**Affected Models:** 490-SU, 490-SUA, 490-SUB, 490-SUC, 490-WU, 490-WUA, 483-SU, 483-SUA, 483-SUB, 483-SUC, 478-SU, 478-SUA, 478-SUB, 478-SUC, 678-SU, 678-SUA

**Affected Part Numbers:** 751-19189

**Subject:** Heat Shield 751-19189 Informational Only

Figure 1

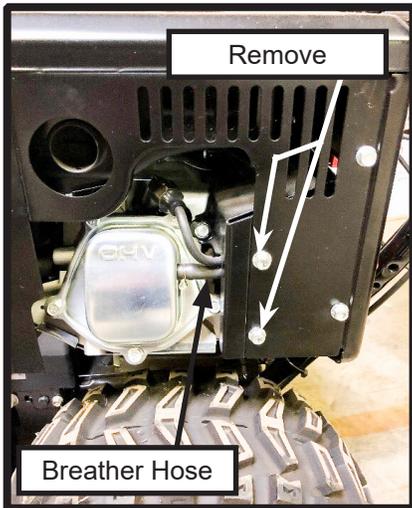
**Purpose:** Prevent freezing of the Breather on Affected Model MTD Snow Engines. Order and install one shield per unit as needed.

1. Park on a firm flat surface.
2. Allow engine to cool to room temperature.
3. Remove two M6 Muffler Shield Screws and Retain. See Figure 1.
4. Maneuver and Align the slots and orifice of **751-19189** into the Left Hand side of the muffler shield as shown in Figure 2.
5. Match up the mounting orifice and reinstall two M6 Muffler Shield Screws. See Figure 3.
